Proposed Permit Modification for the Groundwater Monitoring Plan at the Liquid Effluent Retention Facility and 200 Area Effluent Treatment Facility Operating Unit

U.S. Department of Energy

April 26, 2022

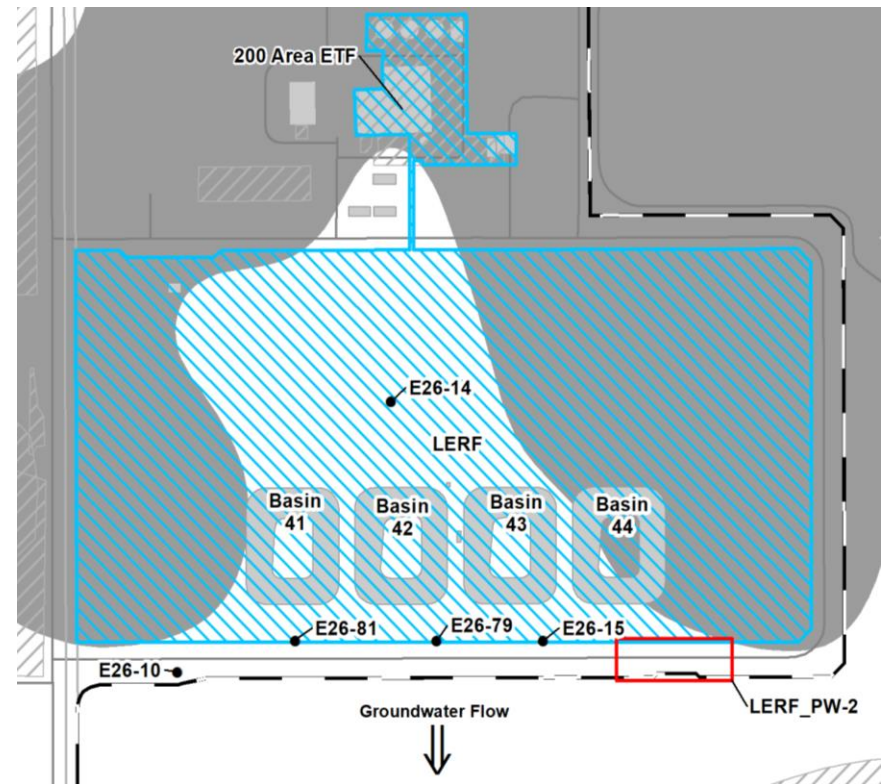
Purpose of the Permit Modification: Revised Well Network

Other changes to the LERF Groundwater Monitoring Plan include the following:

- Incorporation of two new compliance wells to monitor the area downgradient of Basin 41
- Removal of well 299-E26-77 (water-level measurements only)
- Incorporation of one compliance well to monitor the area downgradient of Basin 44 (after the first year of sampling of the new wells)
